STAFF REPORT
(One-Step Final Plat)

CASE NUMBER: SUB 2001-49 -- SPOTSWOOD ADDITION

LOCATION: North side of MacArthur Road, West of Greenwich Road

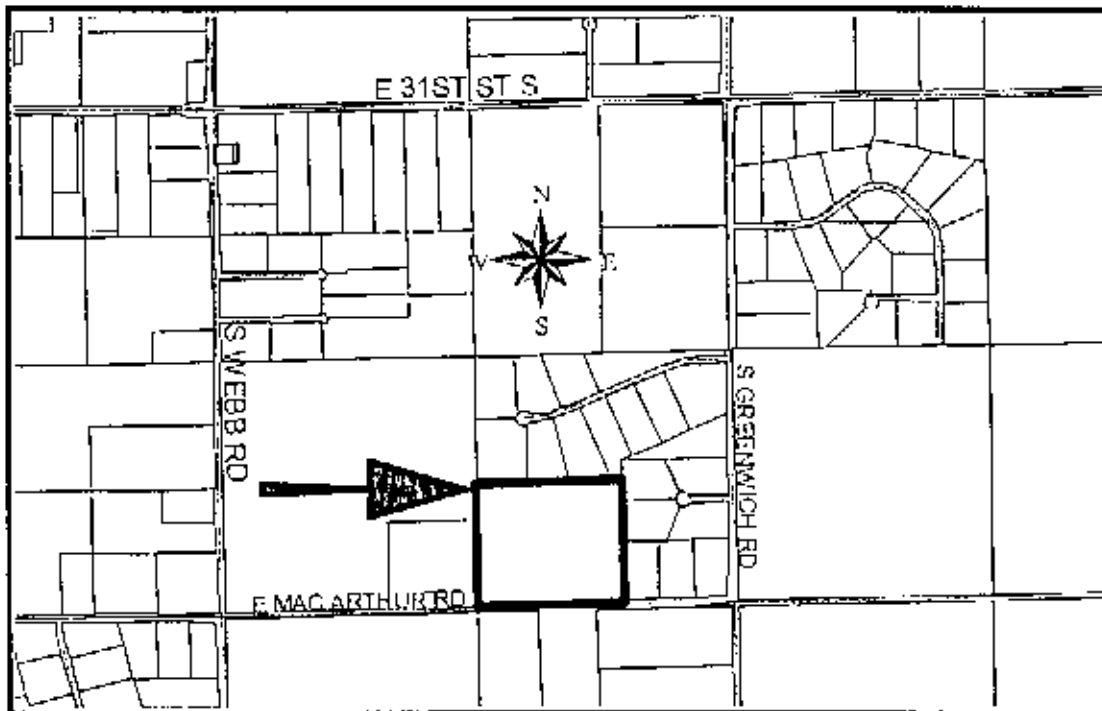
- A. Since neither municipal water nor sanitary sewer is available to serve this property, the applicant shall contact the Environmental Health Division of the Health Department to find out what tests may be necessary and what standards are to be met for approval of on-site sewerage facilities and water wells. A memorandum shall be obtained specifying approval. The applicant proposes sewage lagoons for eight (8) lots. Health Department should comment on floodway reserve constraints.

- D. County Engineering needs to comment on the status of the applicant's drainage plan and the need for platting a reserve for Lots 1, 2, 3, Block 1. *A flood study is required. A minimum pad elevation needs to be established. A drainage reserve is required between Lots 6 and 7.*

- G. The diameter of the turnaround should be increased to 150 feet to conform to Subdivision Regulations.
- H. County Engineering needs to comment on the access controls. The plat proposes one access opening along MacArthur Road for Lot 1, Block 2.

- I. The plat shall be included within one block. Lot 1, Block 2, should be labeled as Lot 8.
- J. The applicant shall guarantee the installation of the proposed street to the 36-foot rock suburban street standard.

- O. The applicant is advised that if ~~platted~~, the building setbacks must be 35 feet along MacArthur Road to conform with the Zoning setback standard for County section line roads.

- P. Approval of this plat will require a waiver of the lot depth to width ratio for Lot 4, Block 1. The Subdivision Regulations state that the maximum depth of all residential lots shall not exceed 2.5 times the width.

- Q. The County Fire Department needs to comment on the plat's street names.
- R. Lot 4, Block 1, does not meet the ~~200-ft~~^{100'} lot width requirement which is measured at the building setback line. An increase in the distance of the building setback from the road would meet the standard.

- S. Approval of this plat will require a waiver for Lot 4, Block 1, which does not conform to the 100 ft minimum lot frontage requirement. The Subdivision Regulations require the lot frontage to be 50% of the required lot width.
